UNITED STATES PATENT AND TRADEMARK OFFICE

APPLICATION NO.	FILING DATE	FIRST NAMED INVENTOR	ATTORNEY DOCKET NO.	CONFIRMATION NO.
10/812,449	03/29/2004	Pauline Maria Foster-Hamilton	0707-00342 - G00342/US	3169
35758	7590	11/07/2005		
GKN DRIVELINE NORTH AMERICA, INC 3300 UNIVERSITY DRIVE AUBURN HILLS, MI 48326			EXAMINER DUNWOODY, AARON M	
			ART UNIT	PAPER NUMBER
			3679

Office Action Summary

DETAILED ACTION

FIG. 1

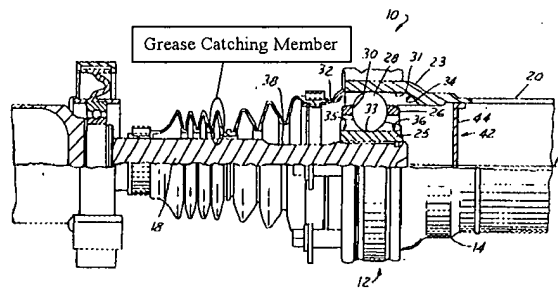
In regards to claim 1, in Figure 1, Booker et al disclose an improved boot for use in sealing a constant velocity joint and ball spline joint assembly, the boot comprising:

In regards to claim 24, in Figure 1, Booker et al disclose an external diameter of the grease catching member being generally greater than external diameters of either the first stabilizing member or the second stabilizing member.

In regards to claim 25, in Figure 1, Booker et al disclose an external diameter of the first stabilizing member being generally less than an external diameter of either the second stabilizing member of the outer race of the ball spline joint.

The Applicant argues that Booker does not disclose the features of claim 1, in particular, a grease catching member. The Examiner disagrees. Booker's Figure 1 below clearly illustrates a grease catching member.

Therefore, Booker anticipates the claimed invention.
